FD class Rule change Submissions
25 September 2005
Proposed effective date 1 March 2006

The following submissions are proposed Flying Dutchman class rule changes for 2006. These proposed changes have been drafted by the FD technical committee and approved by IFDCO at the World Championships in Balatonfoldvar, Hungary

Peter Hinrichsen
FD Class Chief Measurer

Genoa Sheet Fairlead Rule 37

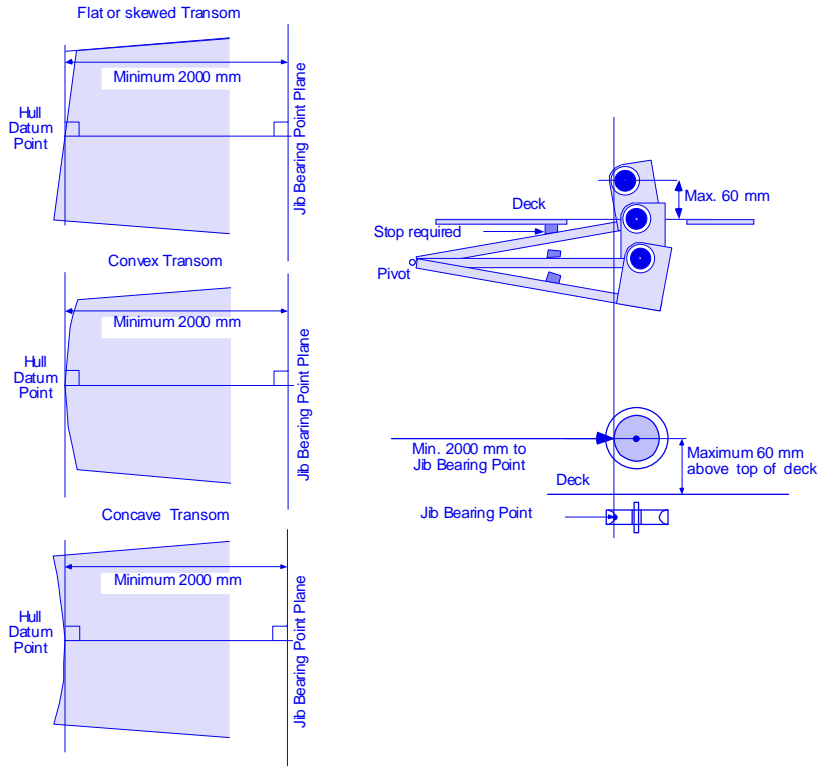
37. The bearing point of the jib sheet on its fairlead must be forward of a plane perpendicular to the deckline and 2000 mm along the deckline from the **transom**. It must be impossible to fix the bearing point of the jib sheet on its fairlead, or to extend the operational clew cringle of the jib, aft of this plane. The bearing point of the jib sheet on its fairlead must not exceed a maximum of 60 mm from the upper side of the deck. The bearing point of the jib sheet is the after most point of the bottom of the groove of a sheave, or the forward side of the opening of a fairlead for the jib sheet. **(See diagram)**

The present rule limits the jib fairlead to being within 60 mm of the upper side of the deck, i.e. both up and down. The class still wishes the limit above the deck to be 60 mm but to remove the limitation down below the deck. The depth of the bearing point below the deck is difficult to measure precisely, and with the current almost universal fitting is in any case limited to about 70 mm by the hull shell. The diagram on page 26 of the FD rules will be modified to accommodate this rule change.

37. The bearing point of the jib sheet on its fairlead must be forward of a plane perpendicular to the deckline and 2000 mm along the deckline from the **transom**. It must be impossible to fix the bearing point of the jib sheet on its fairlead, or to extend the operational clew cringle of the jib, aft of this plane. The bearing point of the jib sheet on its fairlead must not exceed a maximum of 60 mm **above** the upper side of the deck. The bearing point of the jib sheet is the after most point of the bottom of the groove of a sheave, or the forward side of the opening of a fairlead for the jib sheet. **(See diagram)**

Mast and Boom Rules 57-71

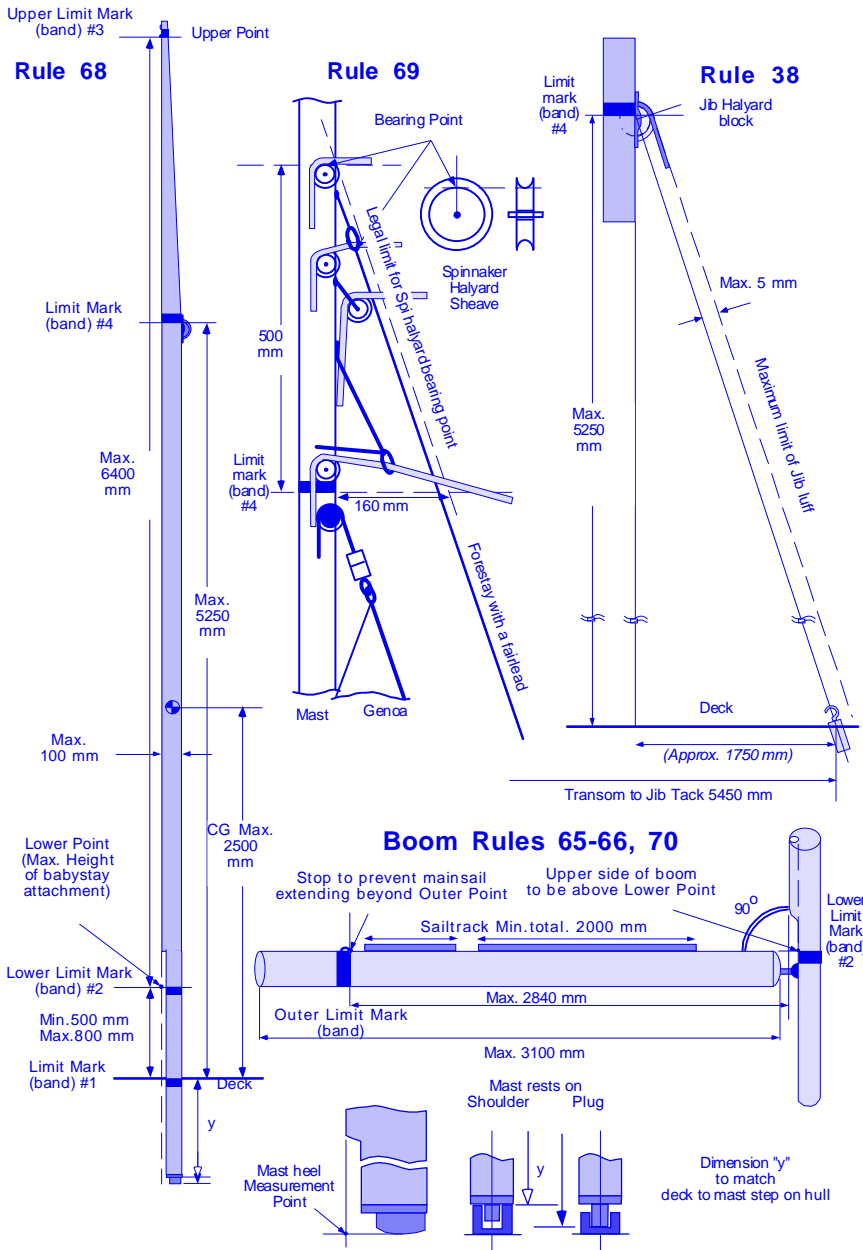
93. Loose-footed mainsails are prohibited.

The ERS do not define “loose footed”. With the advent of carbon fibre booms this has become an issue as booms can be made from tubes with bonded sail track added. However, in this case the major part of the expense is the bonded sail track, so there was a suggestion to dispense with the track. The class was therefore asked for a definitive interpretation of what is meant by “loose footed”. This new wording circumvents this, and follows the 505 rule, except that it specifies a length of track rather than a percentage. It specifically specifies the length of the mainsail foot which is required to be in a track (not the length of the track), i.e. no lacing, while allowing the track to be discontinuous to allow gaps for webbing attachments around the boom for kicking strap, mainsheet etc. The minimum of 2000 mm allows the track to terminate at the kicking strap attachment point.

93. The luff and the foot of the mainsail shall be secured to the mast and boom by sail tracks of total lengths 5000 mm and 2000 mm respectively.

Mainsail Rules 95 and 99

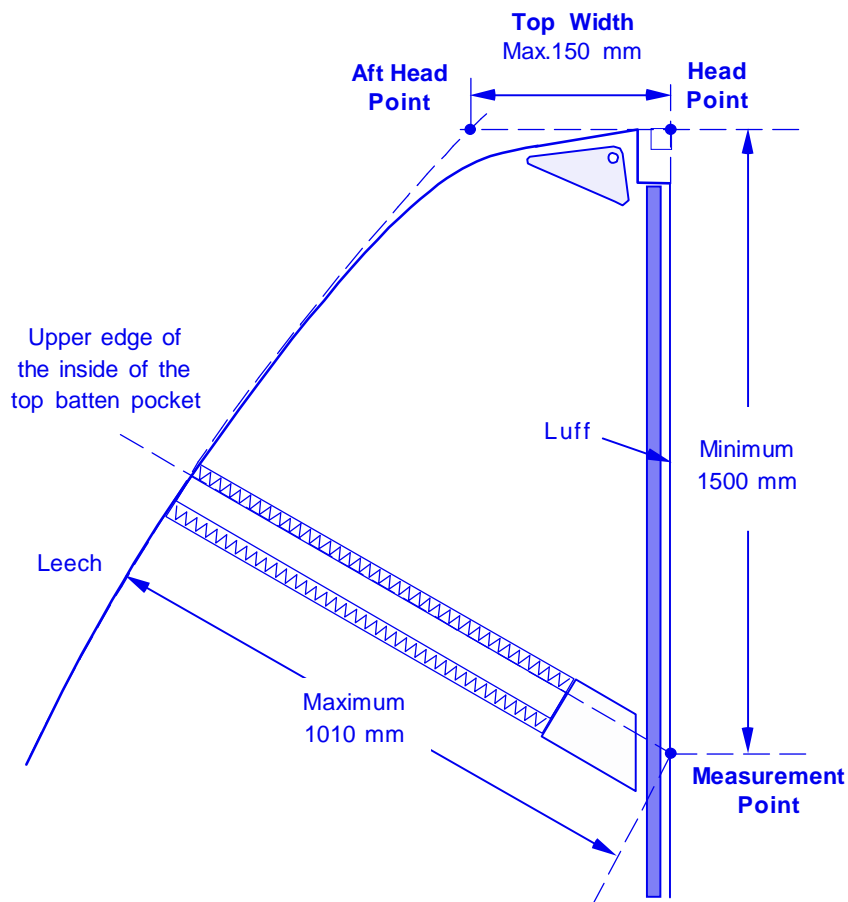
95. The headboard of the mainsail must not exceed a maximum of 150 mm in any direction. **(See diagram)**

This change brings the mainsail rules in line with the ERS definitions, and prevents excessive roach being supported by stiff primary reinforcement. The present rule does not in fact control the top width, but only puts an unnecessary restriction on the headboard, which in any case is not defined in the ERS. The diagram on FD rules page 31 will be appropriately changed.

95. The **mainsail top Width** shall not exceed a maximum of 150 mm

Spinnaker Rules 102-108

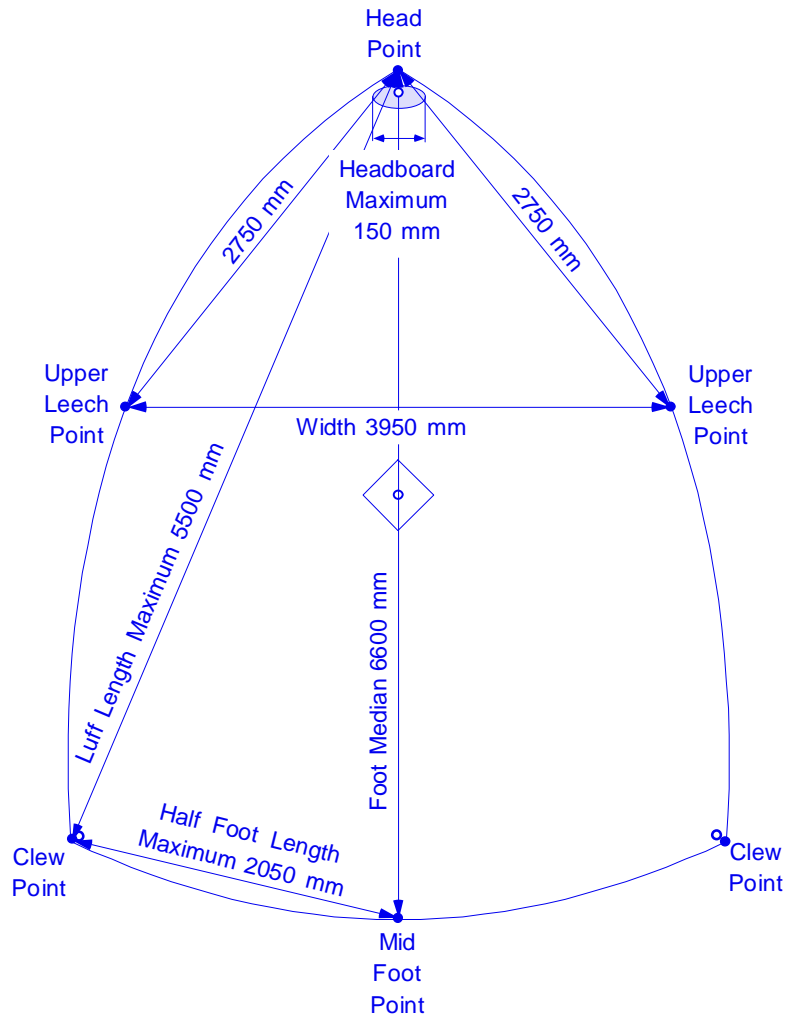
106. The **upper leech points** are at 2750 mm from the **head point**. The spinnaker **upper width** must not exceed a maximum of 3900 mm.

When changing the FD rules to ERS definitions the rule governing the spinnaker width was changed from a double folding rule to the ERS top width definition. In this process the width of 3900 mm was chosen on the basis of a few measurements on FD spinnakers. It now transpires that some FD spinnakers which are legal under the old rule exceed the 3900 mm width. There was never the intention to make such previously legal spinnakers become illegal, and so the minimum top width should be increased to accommodate these sails

106. The **upper leech points** are at 2750 mm from the **head point**. The spinnaker **upper width** must not exceed a maximum of **3950** mm.
